Serial: HNP-12-002

SHEARON HARRIS NUCLEAR POWER PLANT, UNIT NO. 1
DOCKET NO. 50-400 / RENEWED LICENSE NO. NPF-63

Subject: REQUEST FOR LICENSE AMENDMENT
MEASUREMENT UNCERTAINTY RECAPTURE POWER UPRATE
SUPPLEMENTAL INFORMATION

LICENSE AMENDMENT REQUEST
MEASUREMENT UNCERTAINTY RECAPTURE POWER UPRATE
TAC ME6169

FIGURE 2.1-1
REACTOR CORE SAFETY LIMITS - THREE LOOPS IN OPERATION
WITH MEASURED RCS FLOW > [293,540 GPM X (1.0 + C_i)]

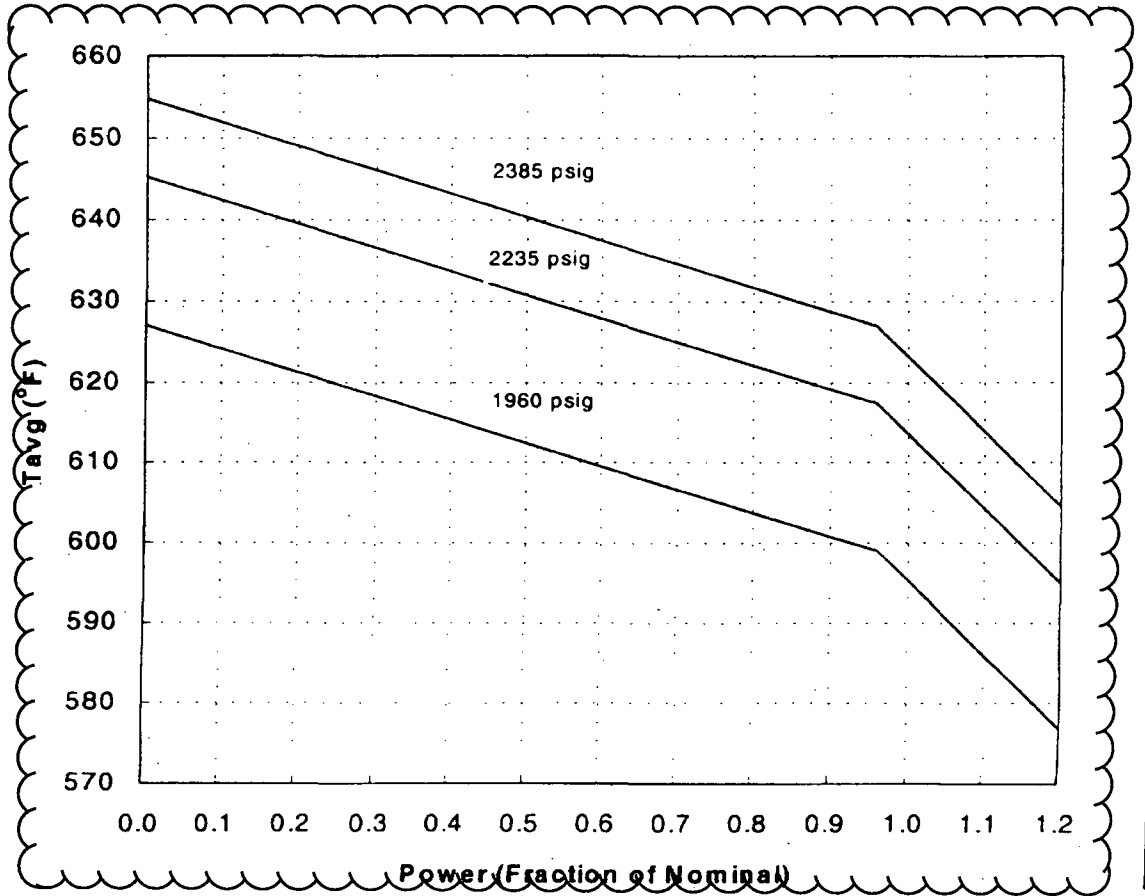
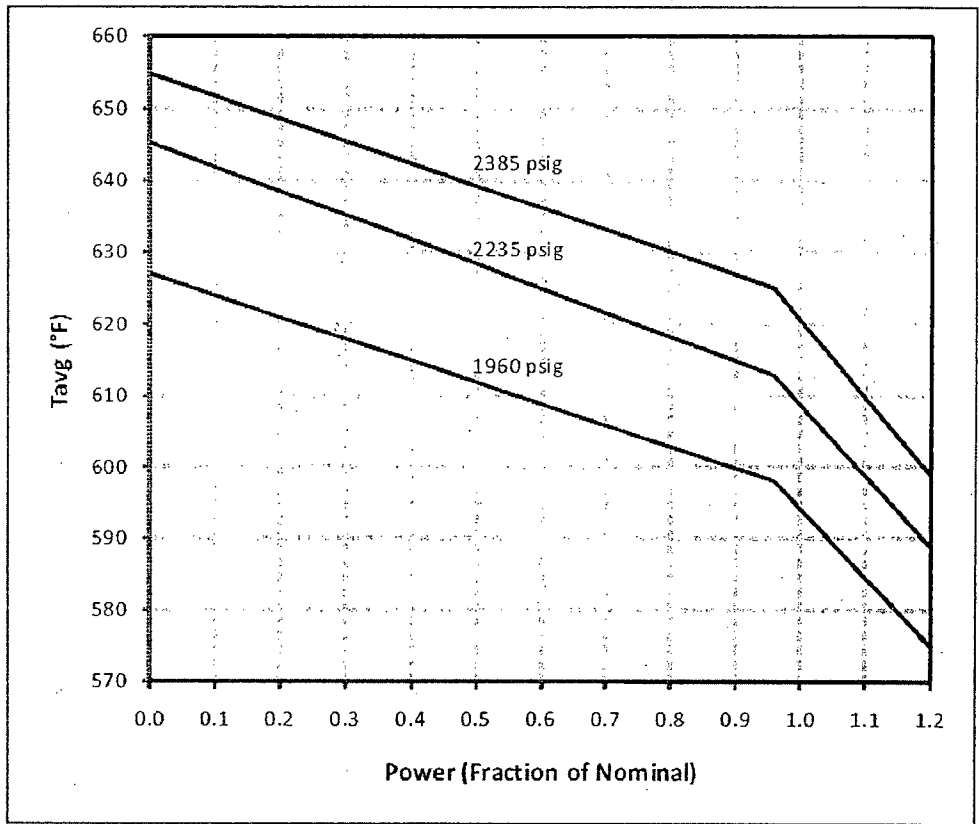
DELETE

Replace with
INSERT A

INSERT A:
